Supervisor/Administrative Professional Checklist

Groundwater & Wastewater Services
Septic Project File & Data Review Worksheet

GWS File #: 8922B WASPS App #: 6761

OPERATION PERMIT for an ON-SITE WASTEWATER TREATMENT & DISPOSAL SYSTEM

Cover Sheet

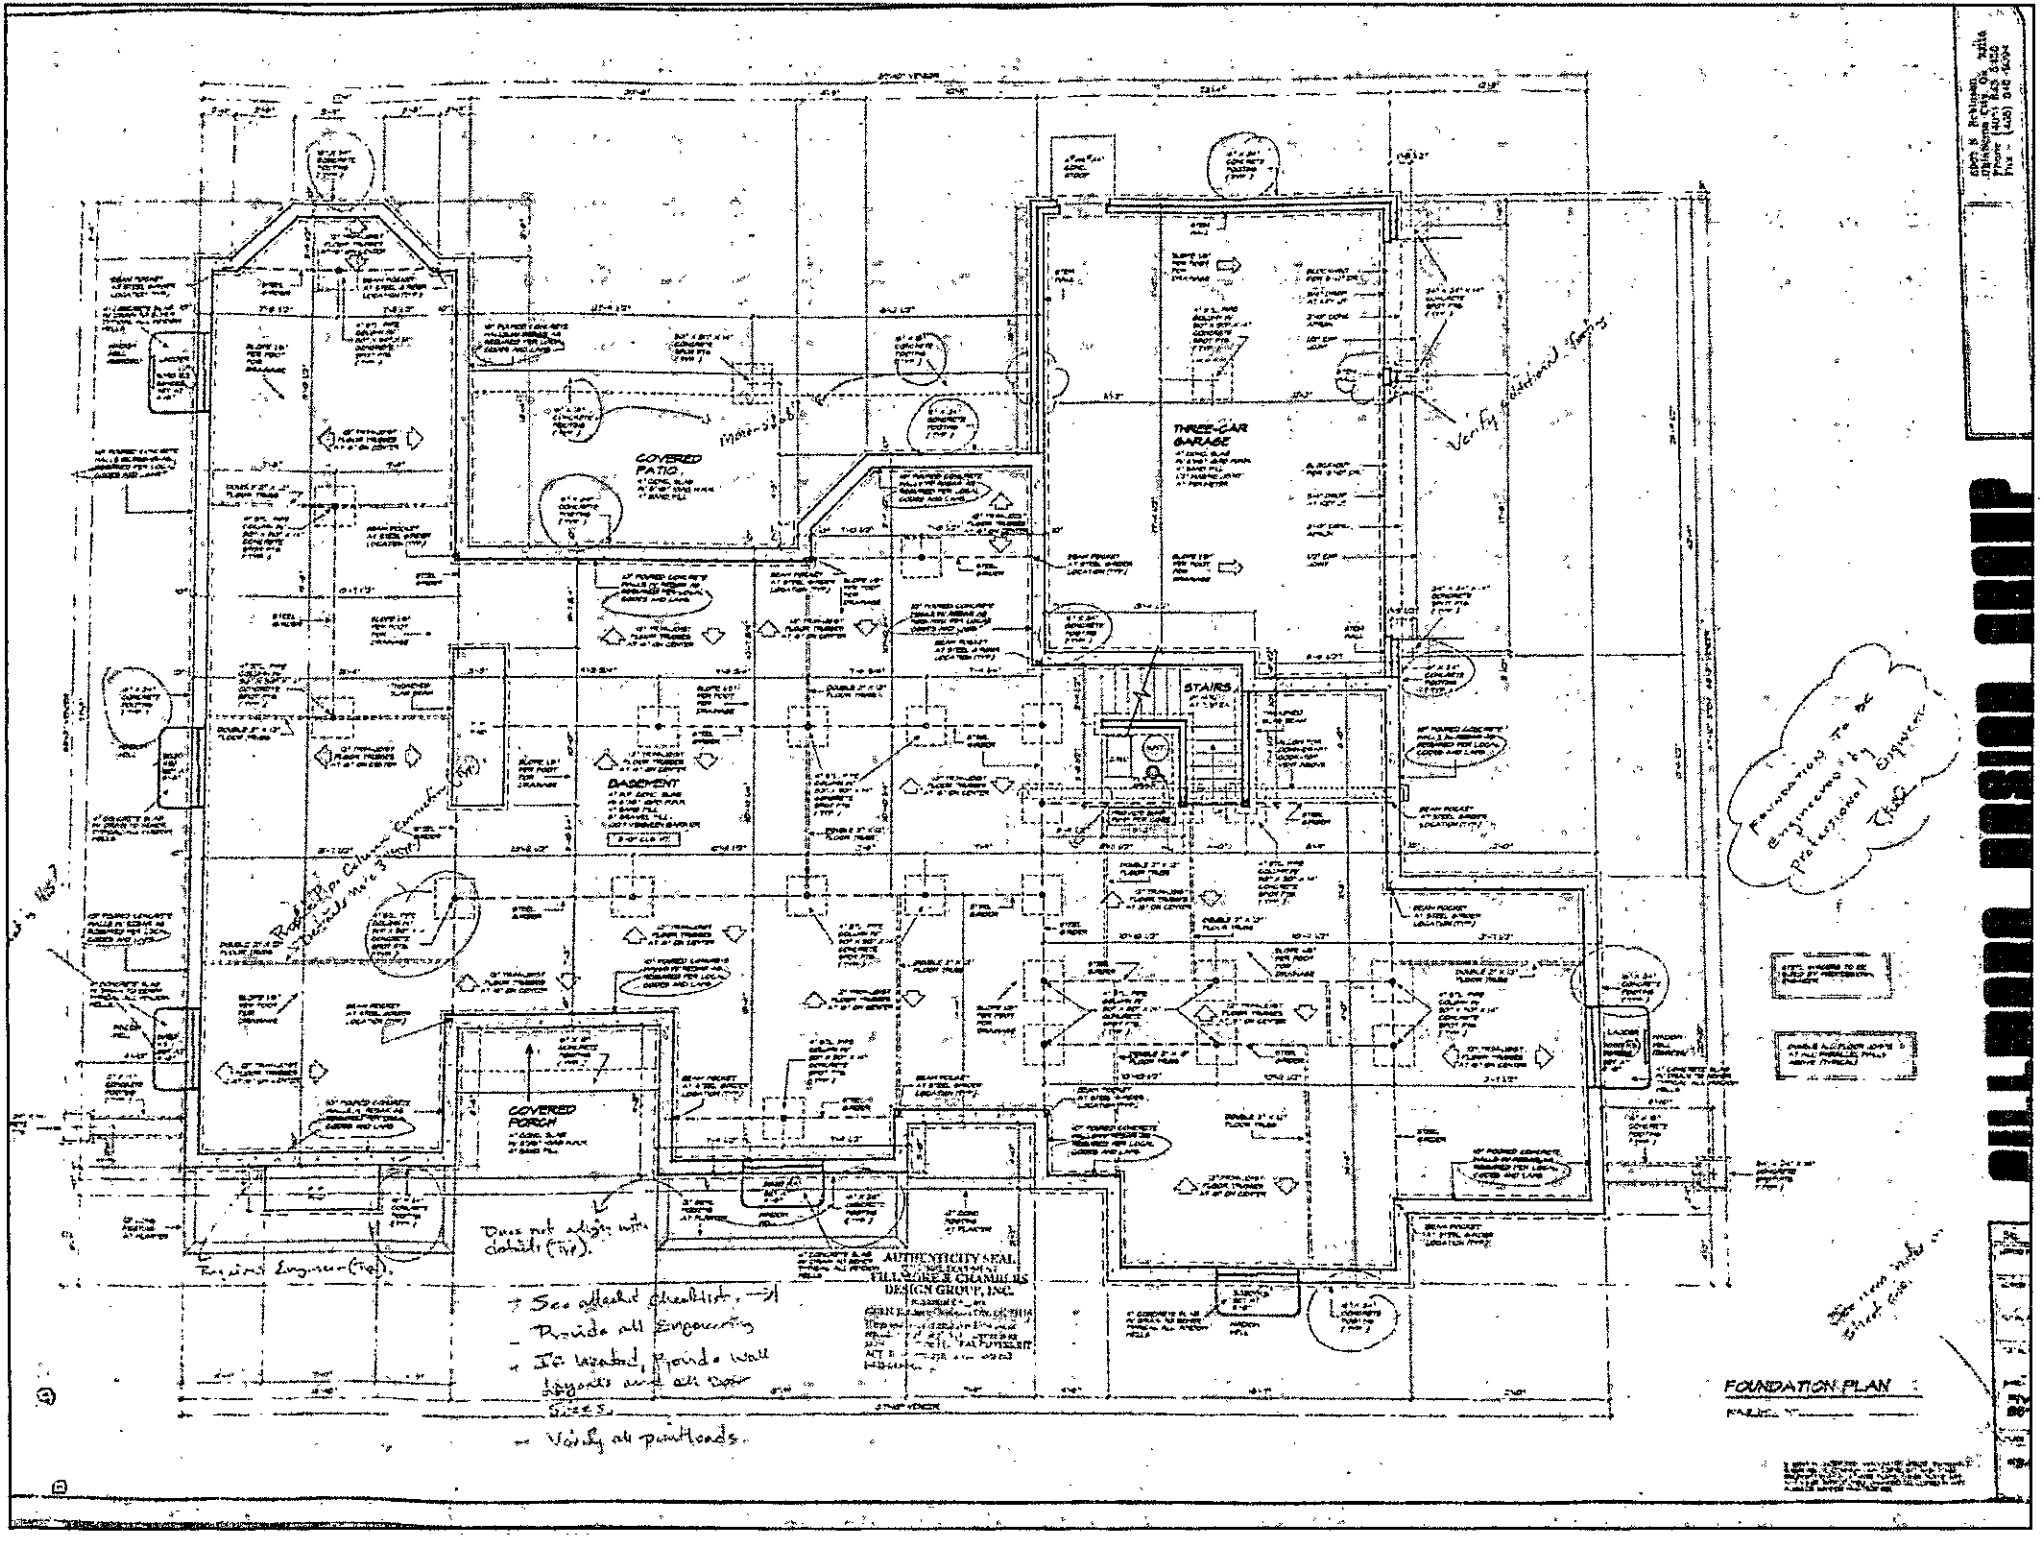
Verify Design for local region. Engineering may vary.

Fireplaces to comply with Chapter 10, Note 2012.

Plans Require Engineer design.

Permit applicant appears to have basement or heated sq. ft. Provide energy compliance details and all framing and finish details

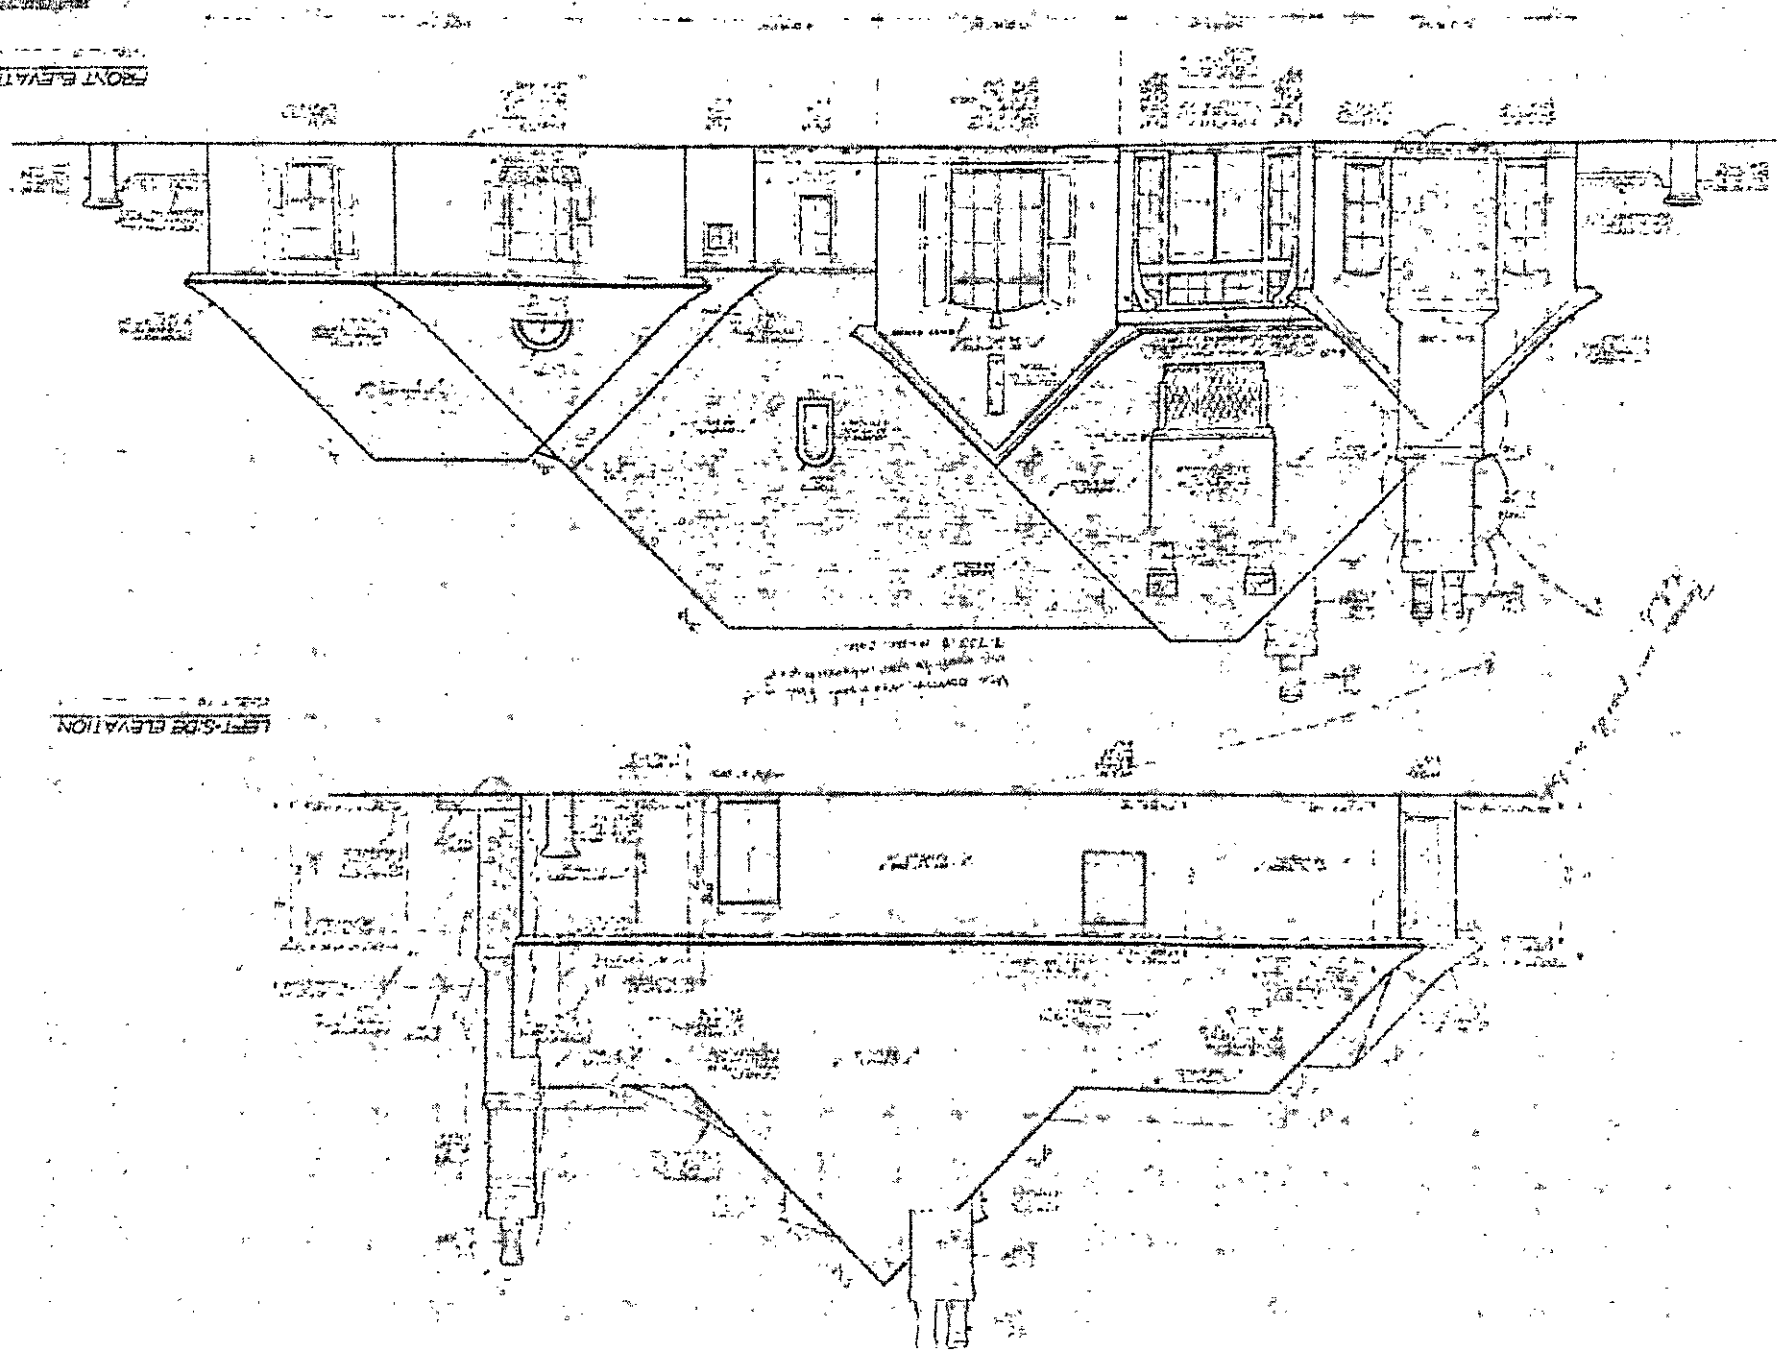
COVERED PATIO
THREE-CAR GARAGE
STAIRS
BASEMENT
COVERED PORCH
Verify elevations
Foundations to be engineered by professional engineer
Does not align with details (Typ).
Required Engineering (Typ).
+ See attached checklist. →
- Provide all Engineering
- If needed, provide wall layouts and all loads
- Verify all pinwheels.
AUTHENTICITY SEAL
FOUNDATION PLAN

REAR ELEVATION

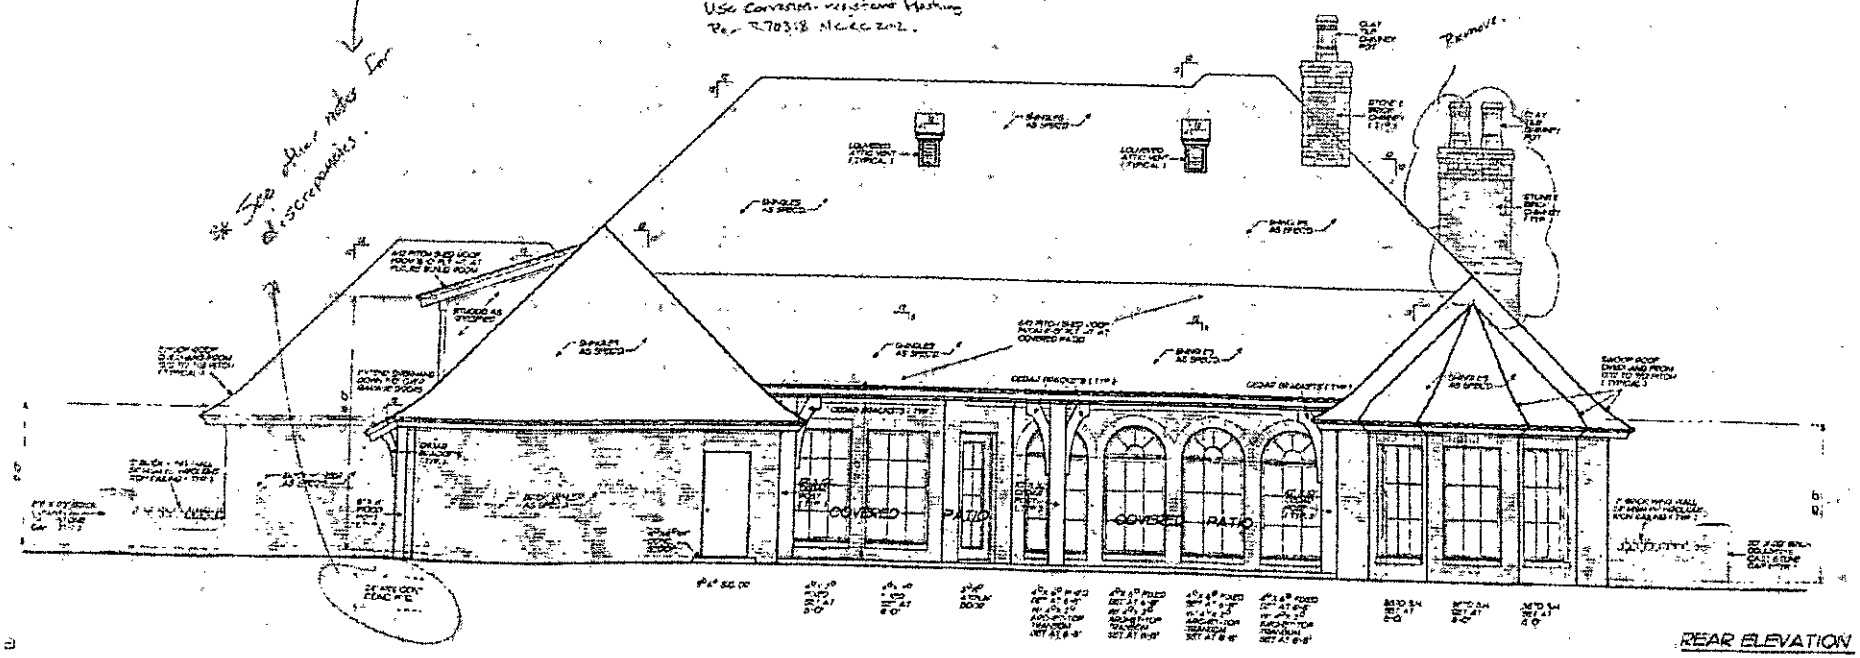
Use Corrosion-resistant flashing
Per R703.8 NCRC 2012.

* See other notes for discrepancies.

DETAILS

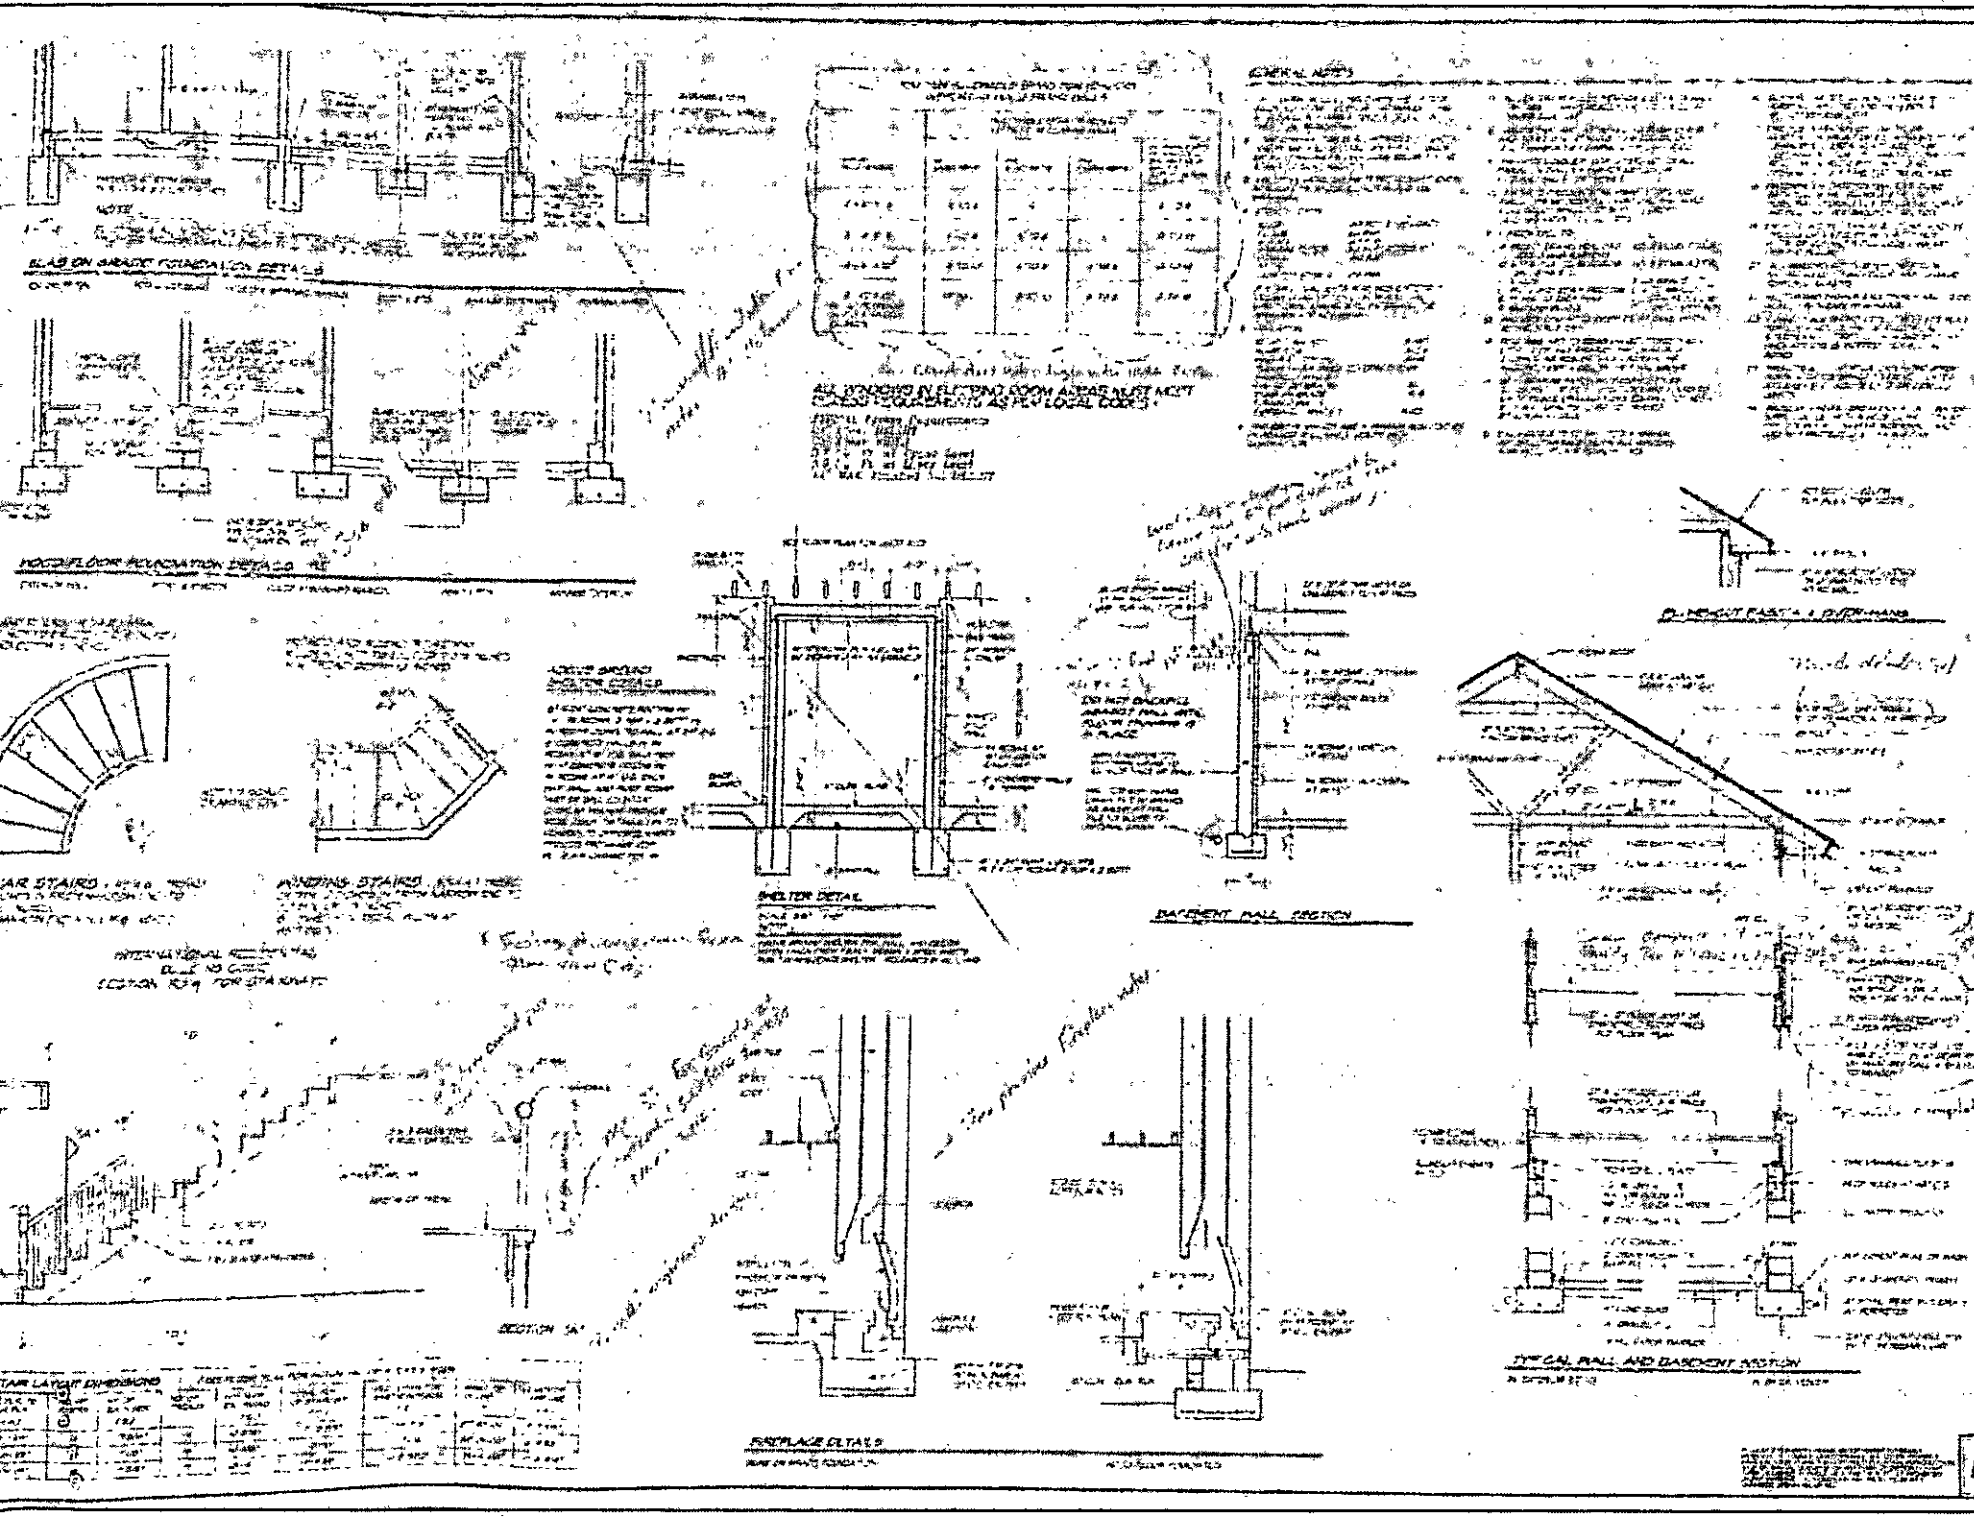
(FUTURE)
BONUS ROOM
3-CAR GARAGE
SECTION "B-10"
ATTIC SPACE
Provide Complete Framing details
COVERED PORCH
ENTRY / GALLERY
GREAT ROOM
COVERED PATIO
SECTION "A-10"
- Provide Complete roof framing details.
- Shingle type.
- Provide all structural information by engineering.
